Date: 03/23/18
To: TRLR45/TRLR70US Trailer Owners
From: Multiquip Product Department
Subject: Trailer Frame Reinforcement — **Mandatory Update**

Service Bulletin

TRLR45/TRLR70US Gusset Installation

Product Group: Trailers	Date Issued: 03/23/18	Expiration Date: 03/23/19	Service Bulletin No. TL20180306
Bulletin Type <input checked="" type="checkbox"/> Mandatory <input type="checkbox"/> Information Only <input type="checkbox"/> Recommended Change		Models/Series Affected: TRLR45 VIN L021853, L021854, L021855, L021856, L021857, L021858, and L021873 TRLR70US VIN L021931, L021932, L021933, L021934, L021936, and L021937

Figure 1. Gussets

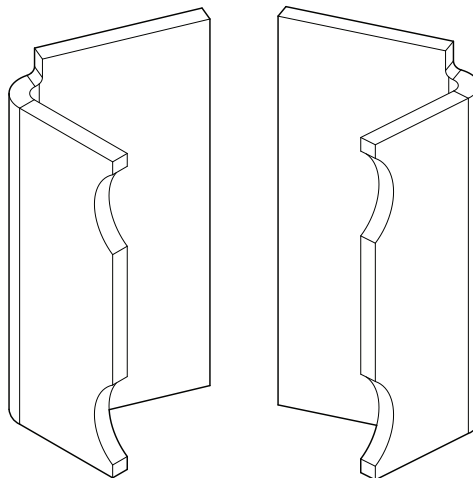
Install trailer reinforcement gussets.

Table 1. Gusset Installation Kit				
Item No.	Part No.	Description	Qty.	Remarks
1	49941-02	Gusset, Jack Crossmember, TRLR45	2	TRLR45 only
1	49927-02	Gusset, Jack Crossmember, TRLR70	2	TRLR70 only

1. Make sure the gussets are accounted for before beginning this installation procedure. Refer to Table 1 and Figure 1.
2. Place the trailer in an area free of dirt and debris. Make sure it is on secure, level ground with chock blocks underneath each wheel to prevent the trailer from rolling.

Figure 3. Paint Removal

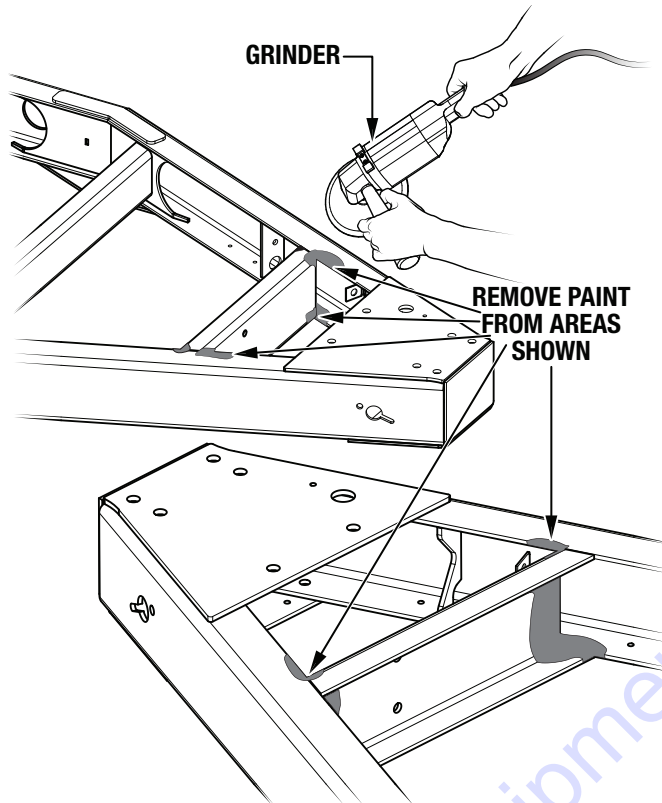
1. Using a grinder, remove the paint from the areas to be heated during welding (Figure 3).

Failure to properly remove the powder coat prior to welding may cause **excessive porosity** in the welds.

Figure 4. Gusset Placement

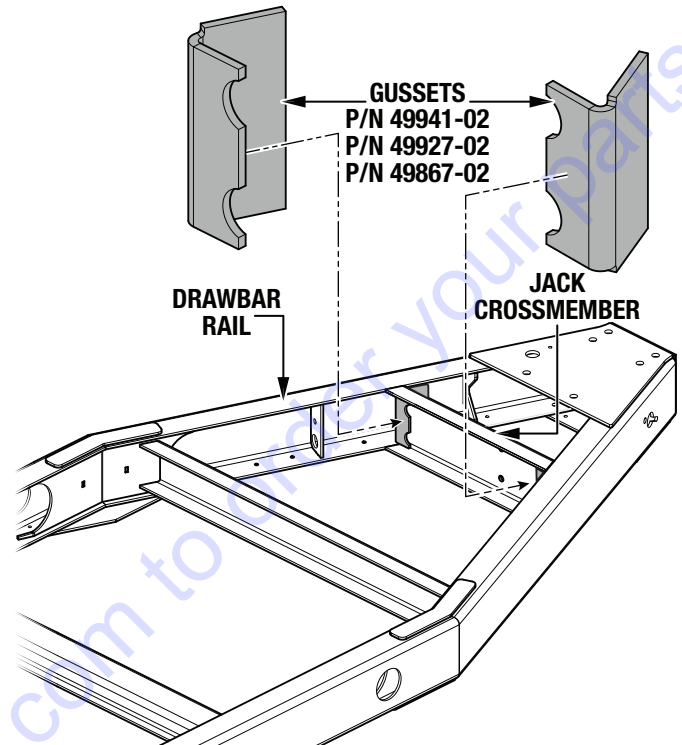
1. Place the gusset (P/N 49941-02, P/N 49927-02, or P/N 49867-02) between the jack crossmember and drawbar rail as shown in Figure 4.

Figure 5. Secure Gusset with Clamp

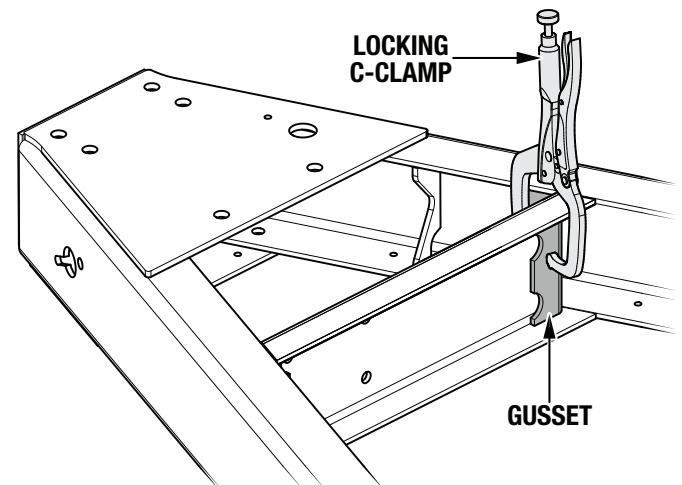
2. Once the gusset is correctly positioned, secure it in place with a locking C-clamp as shown in Figure 5.

Figure 6. Gusset Welding

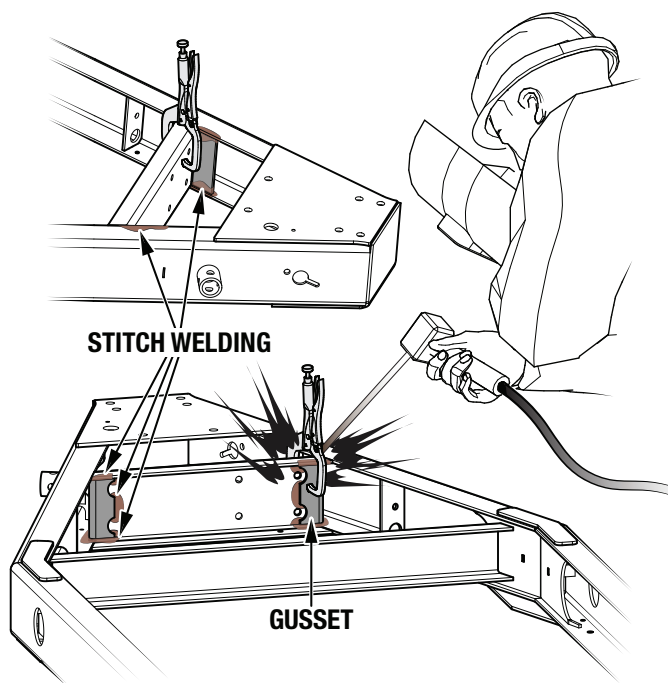
3. Weld the gusset to the trailer frame (Figure 6).

4. Repeat steps 1–3 with the second gusset on the opposite side of the trailer frame.
5. At the completion of the welding process, remove any flux, burrs, or rough edges from the welding area.

Figure 7. Paint Welding Areas

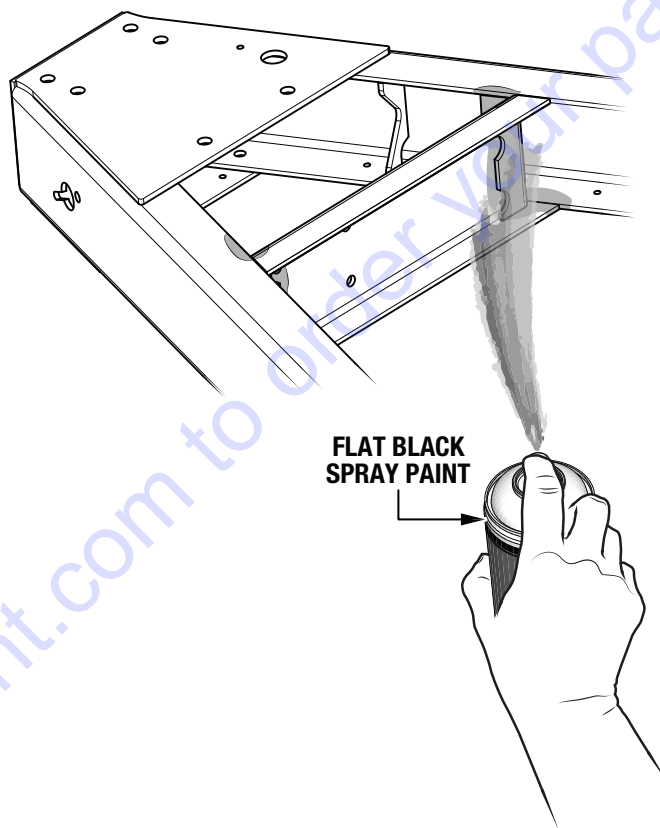
1. Clean all welded areas on the trailer frame with a wire brush, then paint the welding areas with **flat black spray paint** (Figure 7).
